Access Compliance Report

Public Rights-of-Way

(Pedestrian Signals)

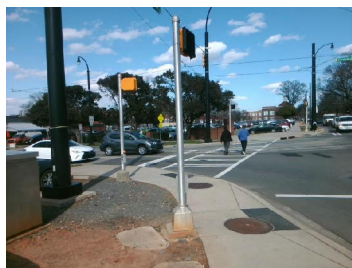
N/A	B 1 FWD Approach Width (in)	N/A	N/A	B 2 FWD Approach Width (in)	N/A
N/A	B 1 FWD Approach Obstruction?	Yes	N/A	B 2 FWD Approach Obstruction?	N/A
N/A	B 1 FWD Approach Obstruction Dist (in)	N/A	N/A	B 2 FWD Approach ObstructionDist (in)	N/A
N/A	B 1 PARA Approach?	Yes	N/A	B 2 PARA Approach?	N/A
N/A	B 1 PARA Approach Constrained?	No	N/A	B 2 PARA Approach Constrained?	N/A
Yes	B 1 PARA Approach Reach (in)	6.0	N/A	B 2 PARA Approach Reach (in)	N/A
N/A	B 1 PARA Approach Width (in)	N/A	N/A	B 2 PARA Approach Width (in)	N/A
N/A	B 1 PARA Approach Obstruction?	Yes	N/A	B 2 PARA Approach Obstruction?	N/A
N/A	B 1 PARA Approach Obstruction Dist (in)	0.0	N/A	B 2 PARA Approach ObstructionDist (in)	N/A
Yes	B 1 Clear Floor Space Slope (%)	1.0	N/A	B 2 Clear Floor Space Slope (%)	N/A
No	B 1 Clear Floor Space XSlope (%)	5.2	N/A	B 2 Clear Floor Space XSlope (%)	N/A
N/A	B 1 PAR Slope (%)	8.4	N/A	B 2 PAR Slope (%)	N/A
Yes	B 1 Height (in)	42.0	N/A	B 2 Height (in)	N/A

Yes	B 1 Pressure (#)	2.0	N/A	B 2 Pressure (#)	N/A
No	B 1 Closed Fist Operation?	No	N/A	B 2 Closed Fist Operation?	N/A

Yes	B 1 Clear Xing Direction?	ClearlyMarked	N/A	B 2 Clear Xing Direction?	N/A
	B 1 Crossing Direction	To SE		B 2 Crossing Direction	N/A
Yes	B 1 DistanceTo XWalk (in)	0.0	N/A	B 2 DistanceTo XWalk (in)	N/A
No	B 1 DistanceTo Curb (in)	89.0	N/A	B 2 DistanceTo Curb (in)	N/A
Yes	B 1 Diameter (in)	2.0	N/A	B 2 Diameter (in)	N/A

Possible Solutions: Replace Signal Push Button With APS Button on New Post. Remove & Relocate Sign.

PROW/ADA: TMUTCD 4e.08, R404.2, R104.2, R209.1
